## *City of El Paso – City Plan Commission Staff Report*

**Case No:** SUSU13-00109 Stevens Addition Replat “B”  
**Application Type:** Resubdivision Combination  
**CPC Hearing Date:** December 5, 2013

STEVENS ADDITION REPLAT B

# ATTACHMENT 3

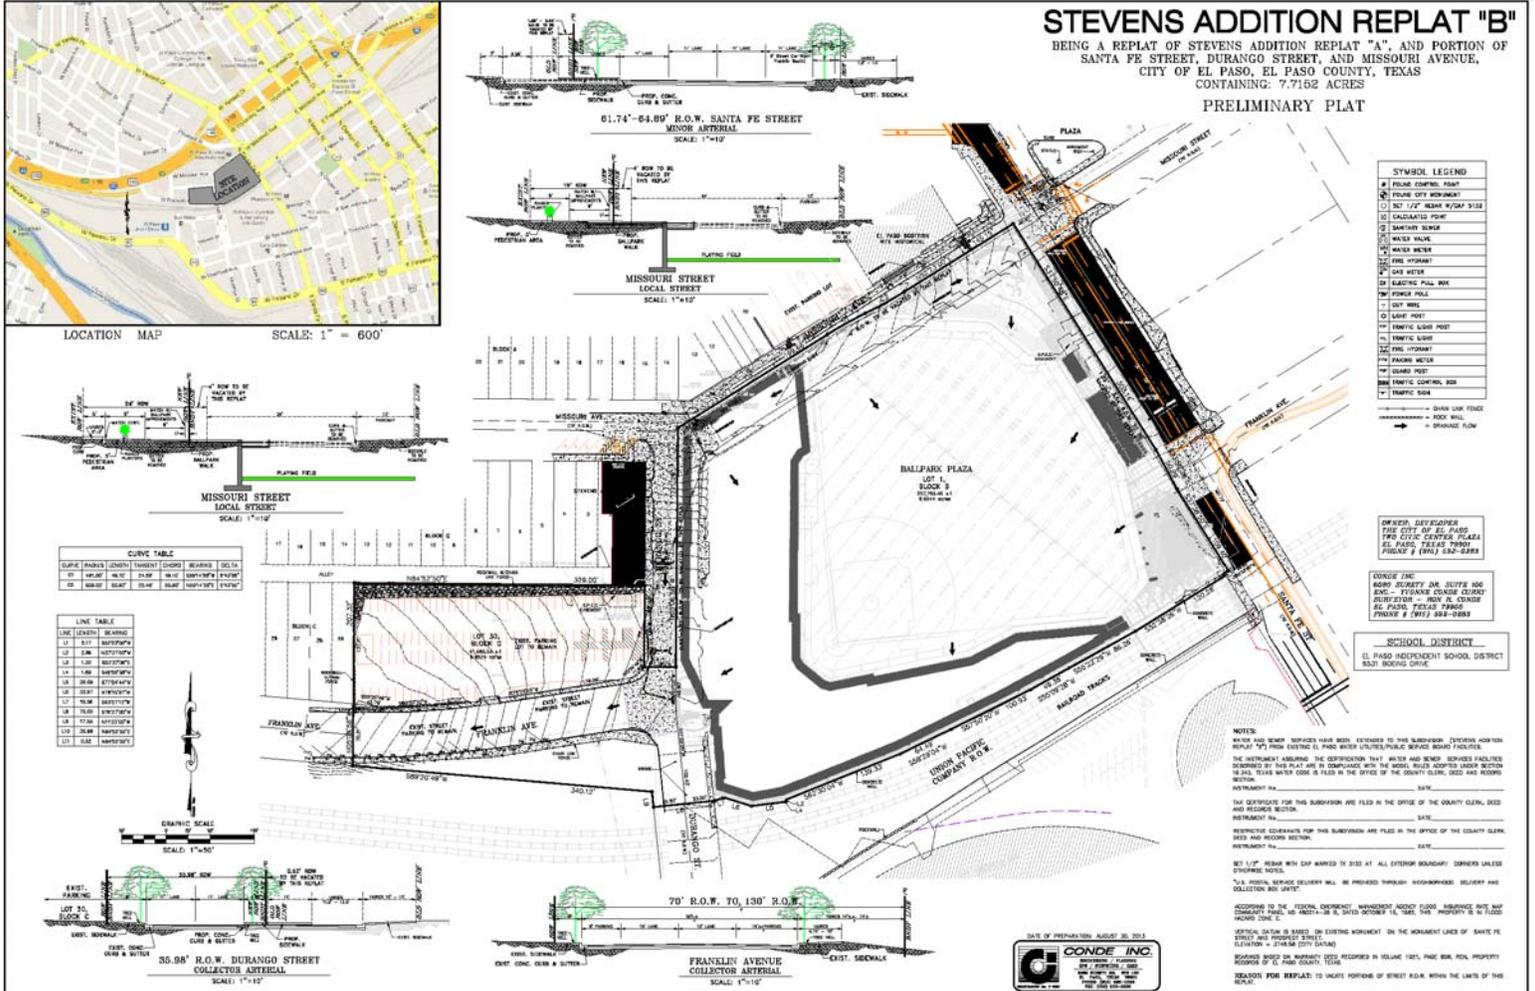
1. No objections.
2. Label all topographic contours and elevations on preliminary plat.
3. Show and label all existing and proposed drainage structures.
4. Verify and dimension the minimum and maximum sidewalk widths are being provided along both sides of Franklin Street, Santa Fe. Street, and particularly along Missouri Street.
5. Show proposed runoff direction on typical street cross sections.
